# REVIEW OF GREERS FERRY DAM DESIGN

MISCELLANEOUS PAPER NO. 3-582

SUBJECT: Review of Greers Ferry Dam Design

FIG. 1 - PLASTICITY CHART

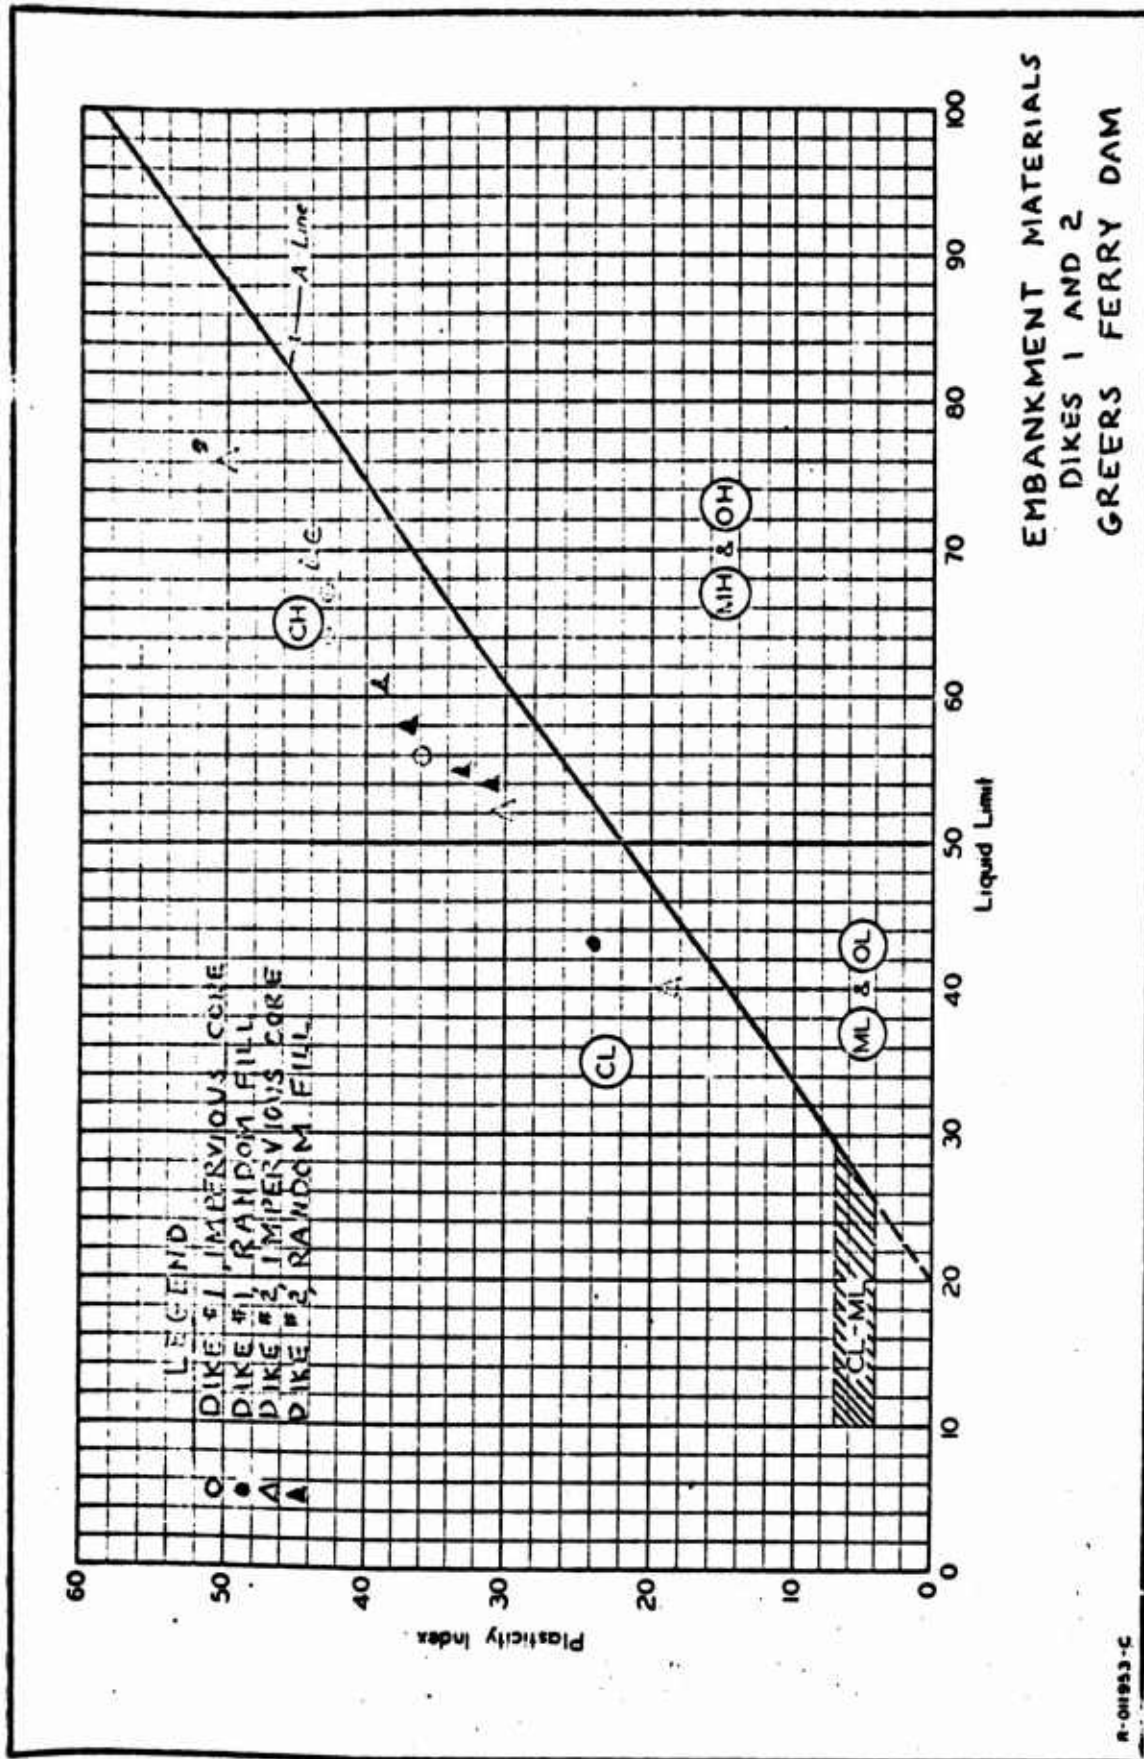
4. Record samples. Record samples taken from the dike embankments indicated a considerable variation in materials in both the impervious core and random fill sections. The materials consisted primarily of lean and fat clays and shale with varying amounts of gravel and sand. Atterberg limits for the embankment materials are shown in the plasticity chart (see fig. 1). Because of the wide variation in material types and the limited number of record samples, a direct comparison of the densities of the record samples with the maximum densities determined in the laboratory could not be made. Results of standard compaction tests listed in table 3 of DM No. 8 indicate optimum water contents ranging from 12.7 to 26.0 percent and maximum dry densities ranging from 95.8 to 123.0 lb/cu ft. These values represent both the core and random fill materials. It was assumed in design that mixing of the borrow soils would occur to such an extent that no one type of material would form an extensive or continuous zone in the embankment and that field densities of 97.5 percent or greater of standard AASHO density would be obtained during construction. It is understood that zonation was effected during construction by selected routing of hauling equipment so that materials with the greater percentages of rock fragments were placed toward the outer slopes of the dikes. Record samples from the impervious core section indicated placement water contents ranging from 14 to 28 percent and dry densities ranging from 96 to 117 lb/cu ft. The data from the record samples indicate an unusually wide range of placement conditions, reflecting the variability of the materials used.

FIG. 2 - RESULTS OF LABORATORY SHEAR STRENGTH TESTS ON RECORD SAMPLES, DIKE No. 1

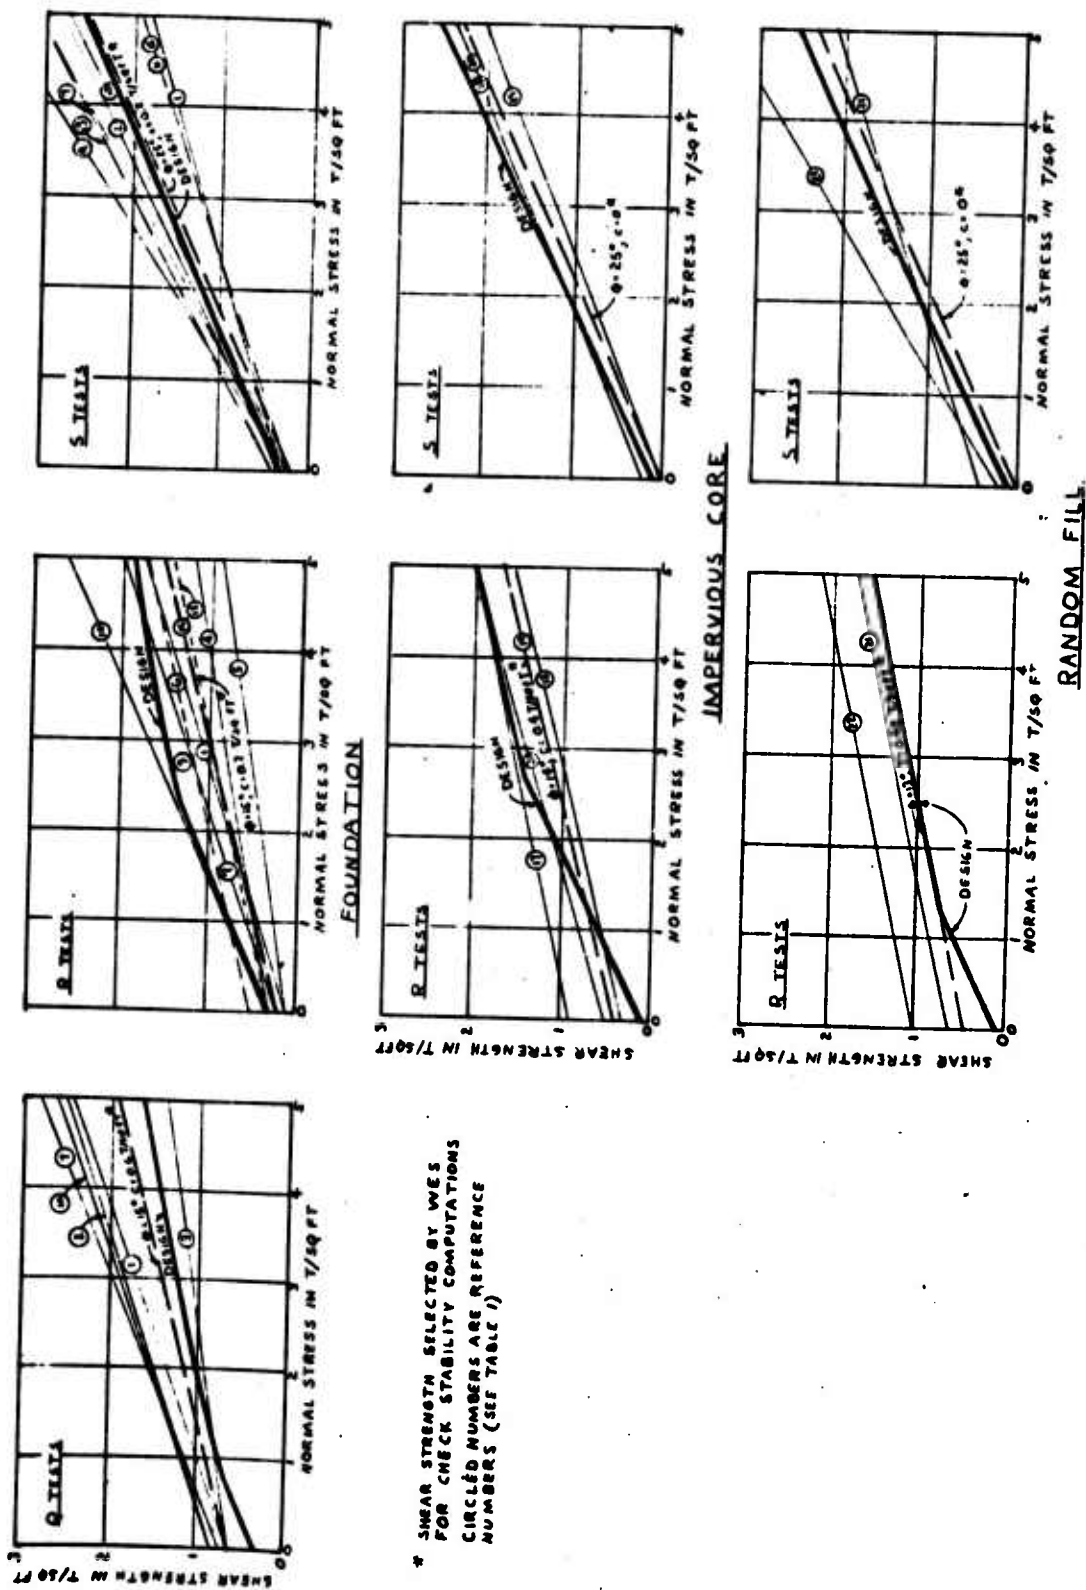
5. Results of laboratory shear strength tests on the record samples are tabulated in tables 1 and 2 and are shown graphically in figs. 2 and 3. The reference numbers shown adjacent to shear envelopes in figs. 2 and 3 correspond to reference numbers shown in tables 1 and 2. Shear strengths were selected for check stability computations utilizing the results of laboratory shear strength tests on record samples from the foundation and from the impervious core and random fill sections of dike 1. Shear strength values selected were as follows:

The above-listed shear strengths are shown graphically in figs. 2 and 3, together with the shear strength envelopes used in design. The design shear strengths consisted generally of combined strength envelopes (see plate 19 of DM 8); consequently, a direct numerical comparison with the shear strengths based on record samples is not possible. In some cases the shear strengths used in design were more conservative than WES selected values, while in other cases the strengths used in design were less than those used in our computations. In general, the shear strengths based on record samples did not differ greatly from the design shear strengths.

FIG. 3- RESULTS OF LABORATORY SHEAR STRENGTH TESTS ON RECORD SAMPLES, DIKE No 2

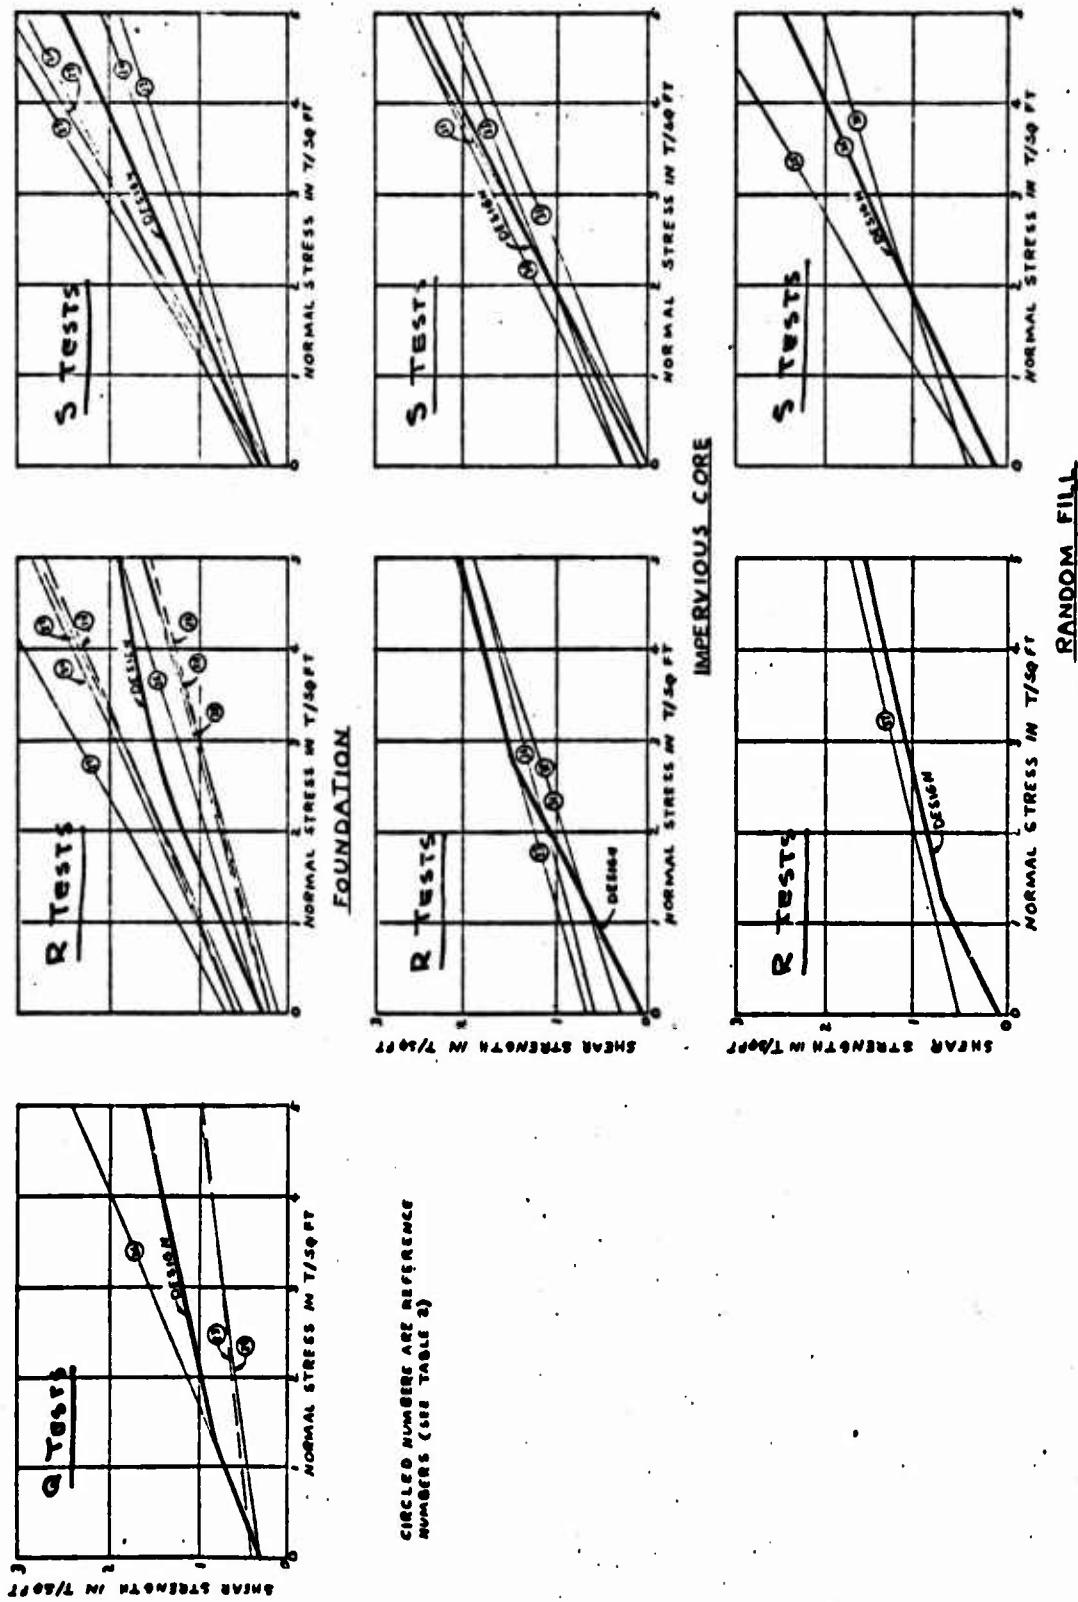
7. Check stability analyses were performed on a typical section of dike 1 (see fig. 4). Dike 1 is about 80 ft high, whereas dike 2 is only about 30 ft high. Strength tests on record samples from dike 2 (see fig. 3) indicate that materials used in dike 2 were similar to those used in dike 1. Although no stability analyses were performed on dike 2, it is considered that this dike is inherently more stable with respect to sliding than dike 1 because of its lesser height.

FIG. 4. CRITICAL ARC FOR STABILITY ANALYSIS OF DIKE NO.1.

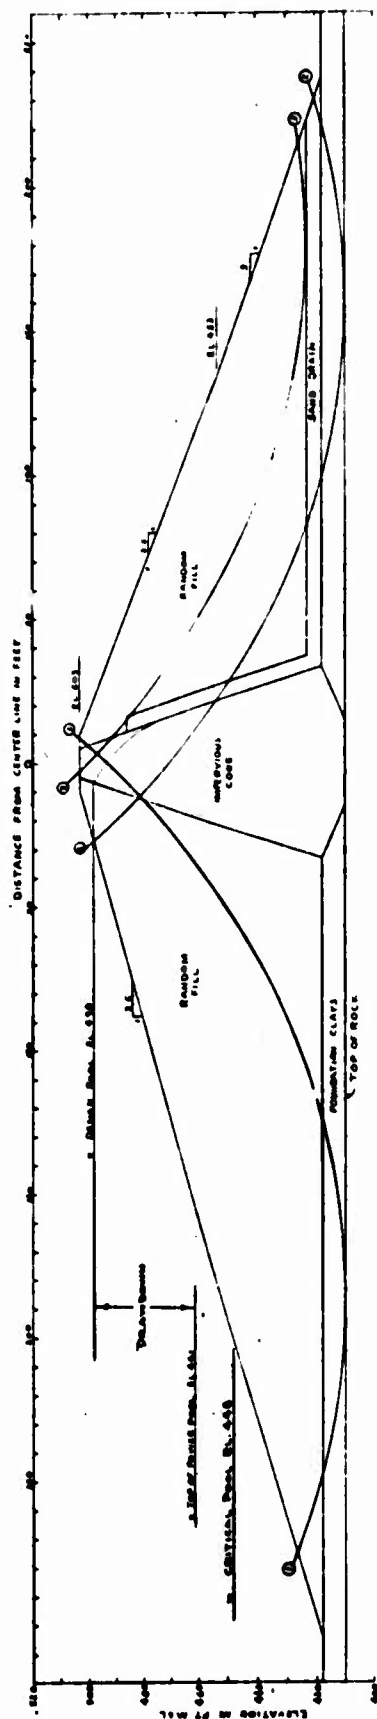
8. Results of the stability analyses are shown in table 3. The factors of safety shown are the most critical of several arcs analyzed. The locations of critical arcs are shown in fig. 4. For comparison, the factors of safety computed for design are also shown in table 3. A close agreement may be

noted between WES computed factors of safety and the factors of safety computed for design, except for the construction condition. The WES factor of safety for the construction condition was 2.47 as compared to 1.7 computed for design. Based on the results of the stability analyses, it is considered that the dikes are safe with respect to sliding.
